**SUNDRY NOTICES AND REPORTS ON WELLS**  
**Do not use this form for proposals to drill or to re-enter an abandoned well. Use Form 3160-3 (APD) for such proposals.**

Antietam 9 Fed Com 102H (FKA 304H) API #: 30-025-52256

EOG respectfully requests an amendment to our approved APD for this well to reflect the following changes:

Proposed Wellbore

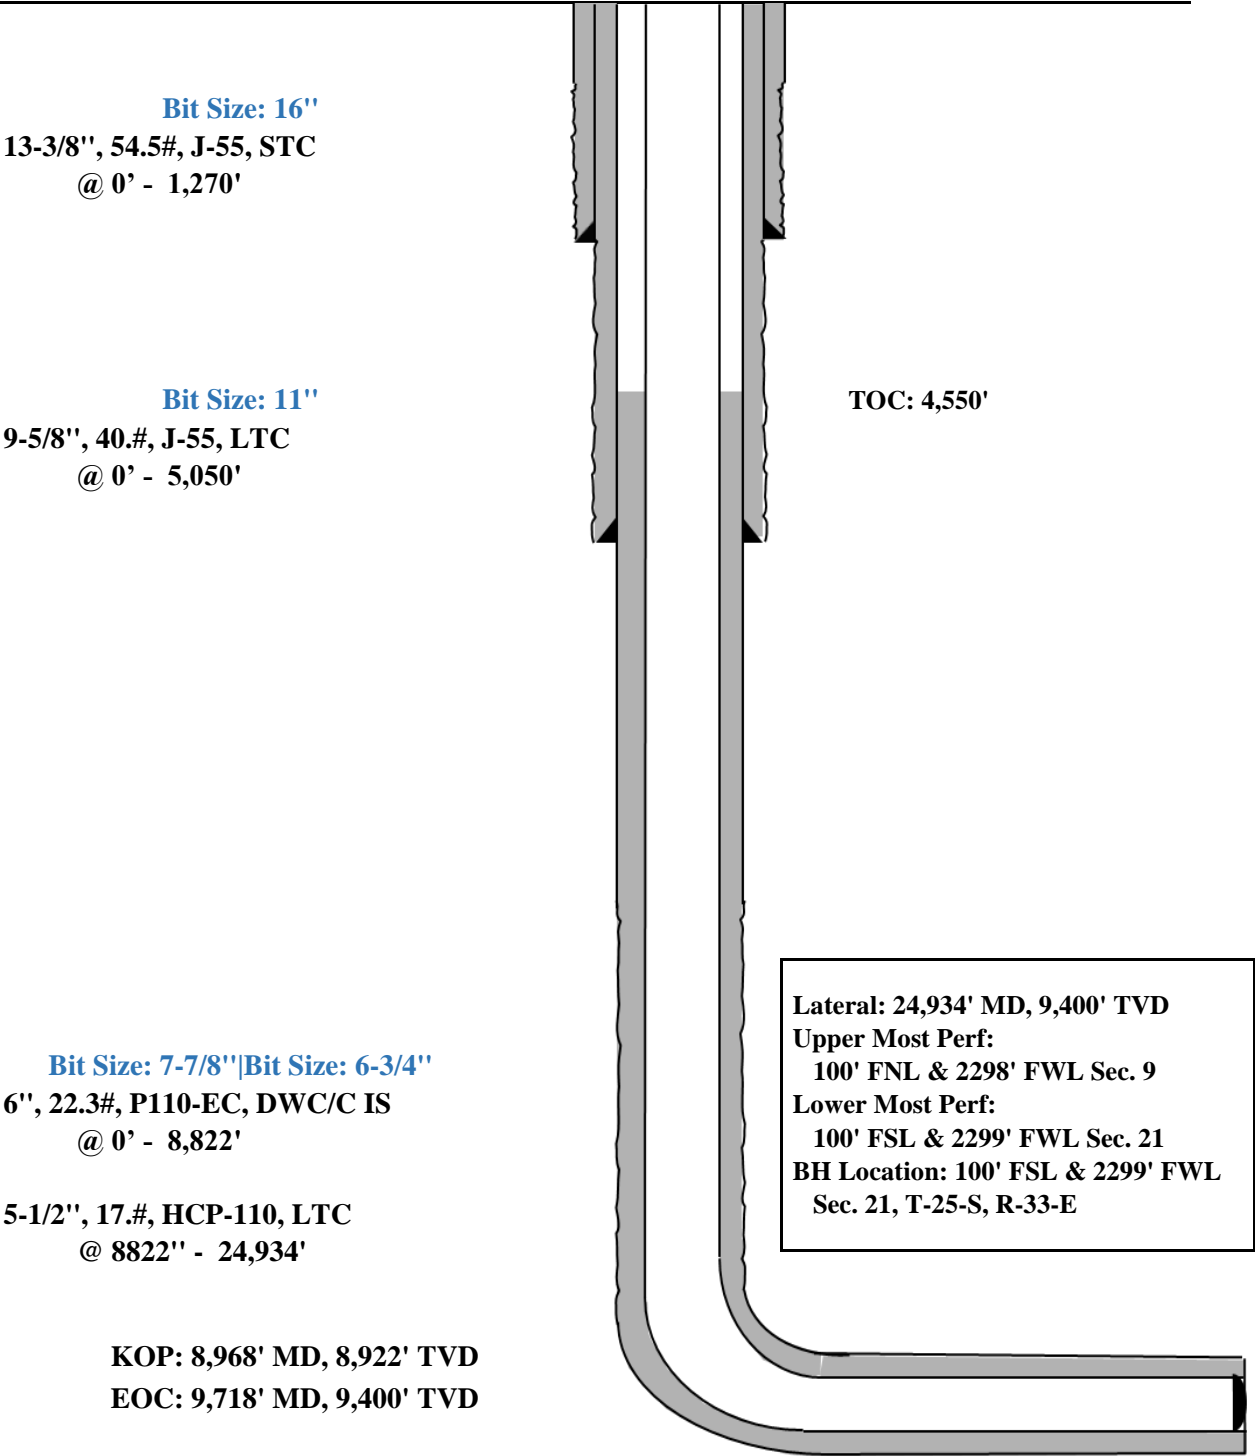
Change name from Antietam 9 Fed Com 304H to Antietam 9 Fed Com 102H.Change BHL from T-25-S, R-33-E, Sec 16, 2540' FNL, 2170' FWL, Lea Co., NM,  
to T-25-S, R-33-E, Sec 21, 100' FSL, 2299' FWL, Lea Co., N.M.

Change target formation to Leonard A.

Update casing and cement program to current design.

## Proposed 11" Hole with 9.625" 40# J55/HCK55 LTC Casing

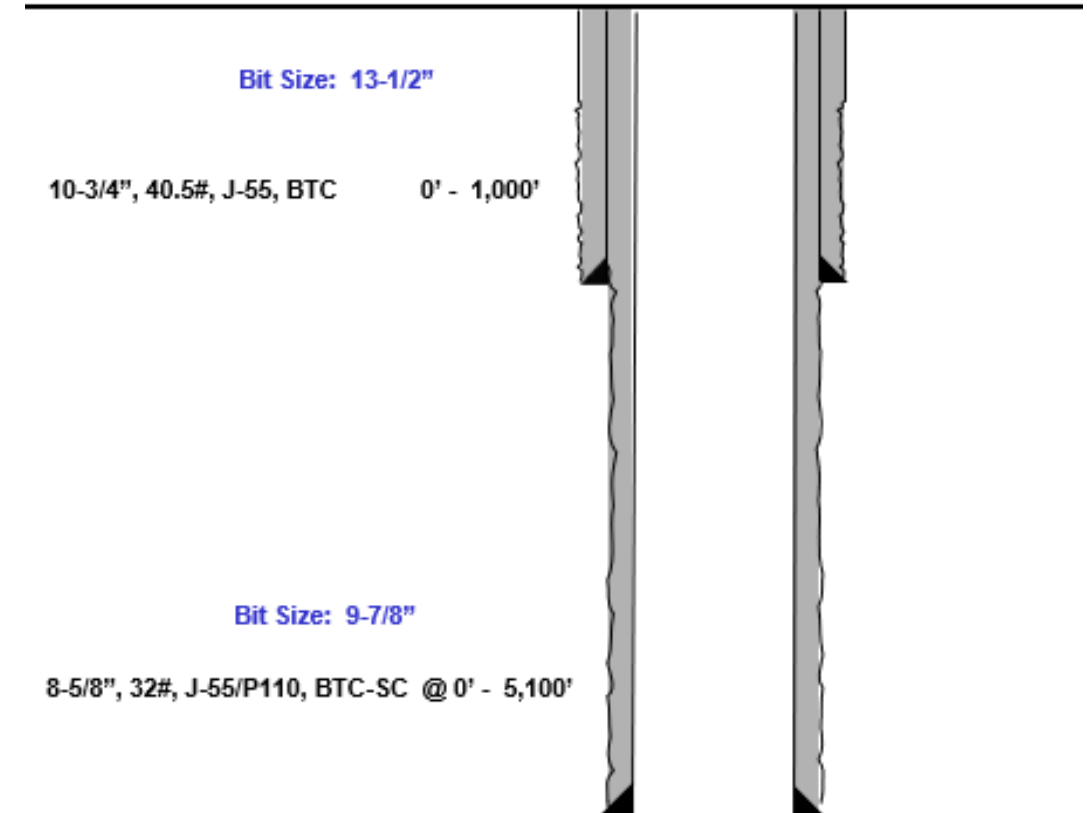
**EOG request permission to allow deviation from the 0.422" annulus clearance requirement for the intermediate (salt) section from Onshore Order #2 under the following conditions:**

- The variance is not applicable within the Potash Boundaries or Capitan Reef areas.
- Operator takes responsibility to get casing to set point in the event that the clearance causes stuck pipe issues

- 11" Bit + 0.52" Average hole enlargement = 11.52" Hole Size
  - 0.9475" Clearance to casing OD

$$= \frac{11.52 - 9.625}{2}$$
  - 0.4475" Clearance to coupling OD
